Date: 27 August 2025

Project No. 880.V11547.00001

**RE: Addendum to Tokanui Consent Applications
Culvert & Stream Design and Contaminated Land Update**

Figure 1. Proposed gabion rock walls at new culvert inlet, with permanent water pool

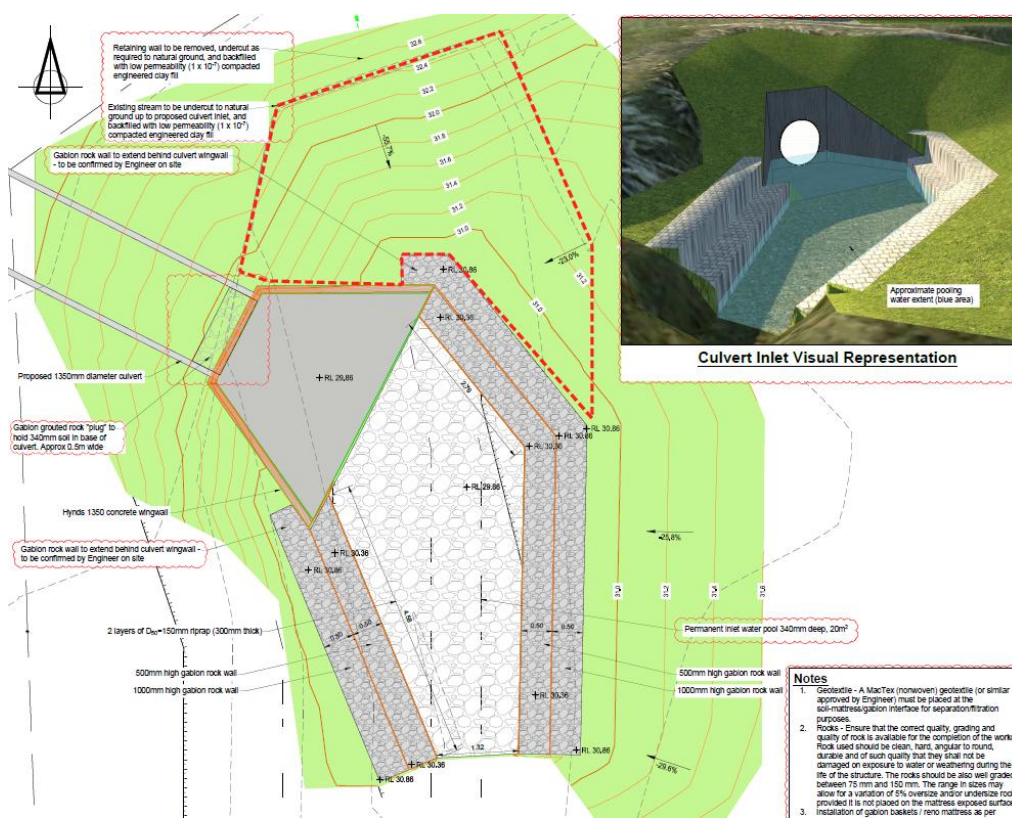
- Gabion and reno mattress rock walls have been added on the base and sides of the culvert outlet, with a central gabion providing energy dissipation and hence scour/erosion protection, while the outlet includes a permanent pond which will provide a resting place for fish (see Figure 1). Original plans did not show any revetment structures.

- Gabions and riprap have been added either side of culvert inlet (terrace structure) and on base for erosion protection, while the inlet includes a permanent pond which will provide a resting place for fish (see Figure 2). Original plans did not show any revetment structures.
